Lot 1 DP 219742, Concord West

Flood Impact Assessment
Addendum 1

Job Number: EN_N15 - 65
April 2017
Rev 0.1

Figure 2.1 - Scenario 3 (Full Floodway / Storage Void Under Entire Building Footprint)

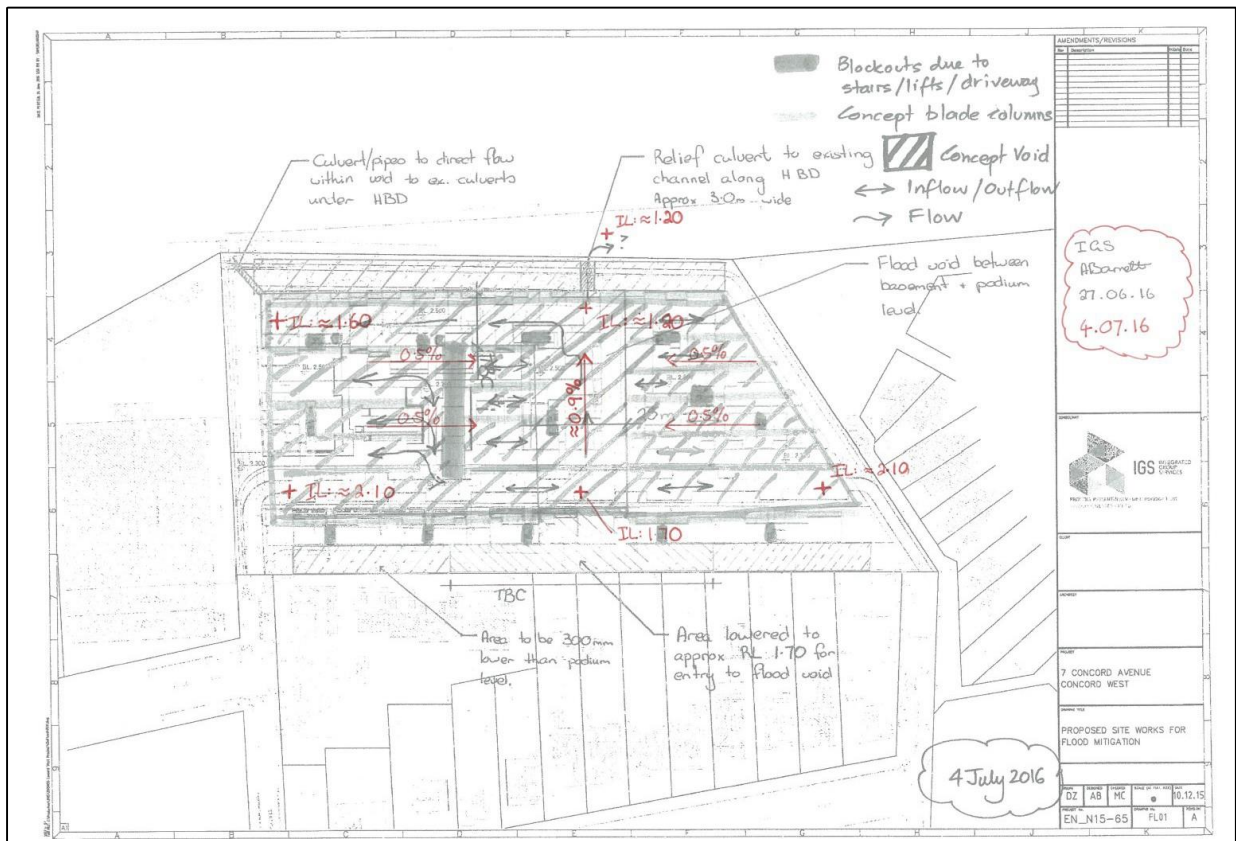
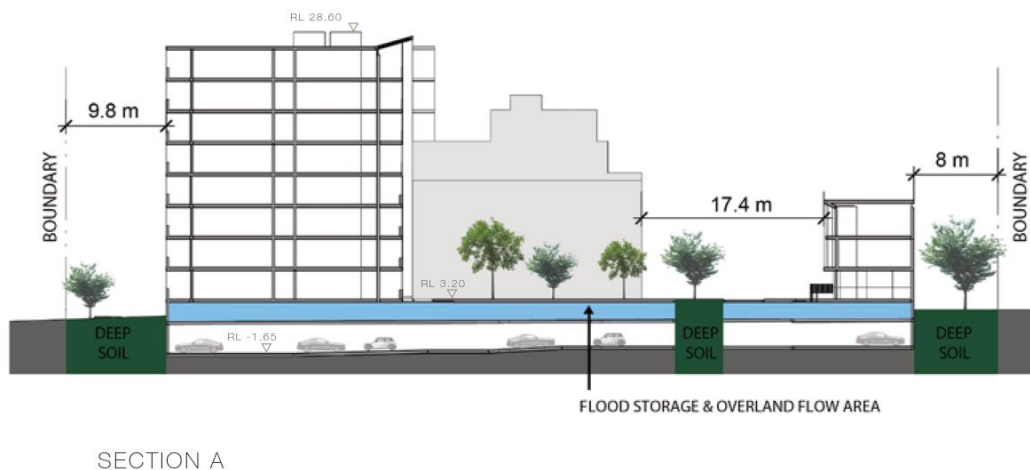
Item	Jacobs Review Comment	IGS Response
1	The flood void is represented in TUFLOW as an unroofed open area, rather than an enclosed chamber as illustrated in the design drawings	N/A . this was a note / observation only
2	The peak water level in the void in the 1% AEP event is 2.05m AHD with a flat water surface across the void area. This allows for approximately 0.75m freeboard to the roof of the void, assuming the roof level is at 2.8m AHD (TBC) thus the 1% AEP is not flowing under pressure. Although the void is represented in the TUFLOW model as having no roof, this is satisfactory for the assessment of up to the 1% AEP event. Refer for discussion on following pages for model performance for events larger than the 1% AEP.	N/A . this was a note / observation only
3	The inlet into the void is modelled as a 62m wide opening along the eastern side of the development, using blocked obstruction (i.e. 100% blocked polygons) objects to constrain the opening on either side of the floodway. This is reasonable. However, the design plans indicate that the floodway is 22m wide only. There is not sufficient information on the design plans to confirm that there is 66m of inlet width. It is suspected that if only a 22m wide void flow entry is modelled, that there would be increases in flood levels on the properties to the east. Any impacts should be confirmed. Refer to Figure 3.	The 60m wide opening is at the rear of the site is all open and represents the eastern boundary of a lowered area at RL 1.70m AHD to increase the inflow capacity through the site. The western part of the lowered area is restricted to 22m width which allows for the flows to be conveyed under the void

4	The outlet opening of the void is not modelled at the minimum floodway elevation of 1.2m AHD as indicated on their design. Instead, the outlet opening has an invert level of 1.85m AHD which means there is a 0.65m high sill at the outlet. IGS should confirm whether the outlet invert should be lowered in the model, noting that doing so is likely to reduce the depths of flooding upstream of the opening (including in the void) and potentially increase flooding and flows downstream. Otherwise, whether the model reflects what is intended, in which case the design drawings may need to be updated. Refer to note on Figure 3.	This has been addressed in the revised model and shown to have negligible effects to the flood model.

- The void area under the building footprint is lowered to the levels shown in Figure 2.3 above. The eastern side is fixed at RL 1.70m AHD, this represents the upstream inflow area. The lower point in the void is in the middle of the western boundary and is fixed at RL 1.20m AHD. This point acts also as the outlet of the void area. The south western corner is fixed at RL 1.60m AHD. The void is graded to its central area at 0.5% grade to force the flows into the opening;

- The flood opening under the building is limited to 22m width along the eastern boundary;
- Part of the setback (60m long) along the eastern boundary is lowered manually within the TUFLOW model to RL1.70m AHD to increase the flood acceptance width from the upstream properties;

Figure 2.3 - Void Plan View (Scenario 3)

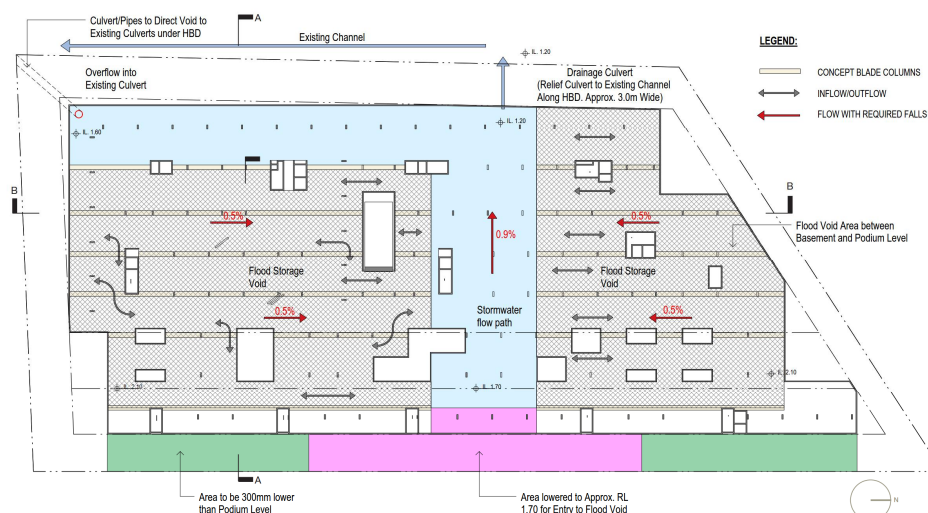
6	<p>It is noted that the sump pit connection to the existing stormwater was not modelled in the IGS TUFLOW model.</p>	<p>The low flow system is modelled now and shown to have negligible effects to the flood model. Refer amended model details.</p>
7	<p>The model does not reflect the lowered corridor along the eastern boundary of the site which is intended to collect overland flows from the eastern adjacent properties and direct them to the void entry. The blocked obstructions in the model are situated in their place. Refer to Figure 3. It is unclear whether the modelled performance of the void entry and changes to flood levels will be affected by precise representation of the lowered corridor, in conjunction with modelling the width of the entry width (if the modelled entry width differs from what is actually proposed).</p>	<p>The lowered area is represented in the TUFLOW model with a constant level of RL 1.70m AHD.</p>
